UNITED STATES PATENT AND TRADEMARK OFFICE

APPLICATION NO.	FILING DATE	FIRST NAMED INVENTOR	ATTORNEY DOCKET NO.	CONFIRMATION NO.
10/619,489	07/16/2003	Minoru Igarashi	04208.0183	8855

Office Action Summary

FIGURE A

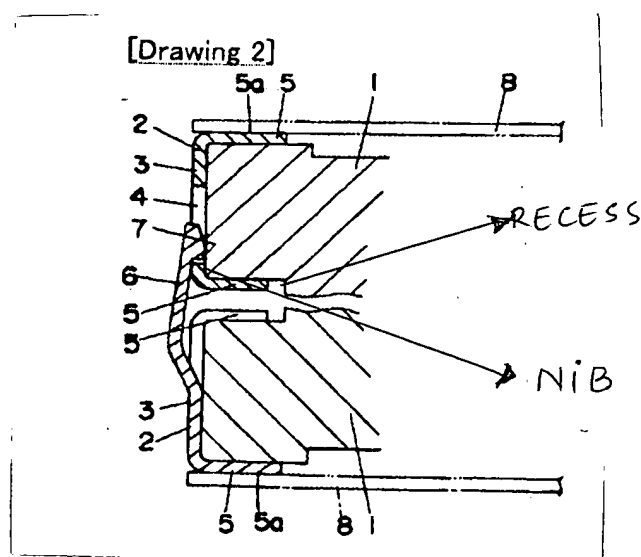
Regarding claims 1 and 9-13, JP05-002385, figures 1-2, disclose a connector for connecting circuit boards with each other, comprising:

- a first connector section (1) disposed on a first circuit board (8) and having contact terminals electrically connected to an electro-conductive layer of the first circuit board; and
- a second connector section (1) disposed on a second circuit board (8) and having terminals electrically connected to an electro-conductive layer of the second circuit board;

wherein when the first connector section is coupled to the second connector section, non-elastic metallic engaging portions (side edge of an engagement hole 4) provided in the first connector section are latched with elastic metallic projections (7) provided on an inner surface of an elastic piece (6) provided in the second connector section to hold the

first connector section on the second connector section, the engaging portions in the first and the second connector sections are nibs (a figure A below) and projections of a metallic holding fixture, respectively, the first connector section having leg portions (5) fixed to the first circuit board and the second connector section having leg portions (5) fixed to the second circuit board, and a recess (the figure A below) is formed for allowing a portion (5) being engaged in the second connector section to advance/retract at a base of the second connector section.
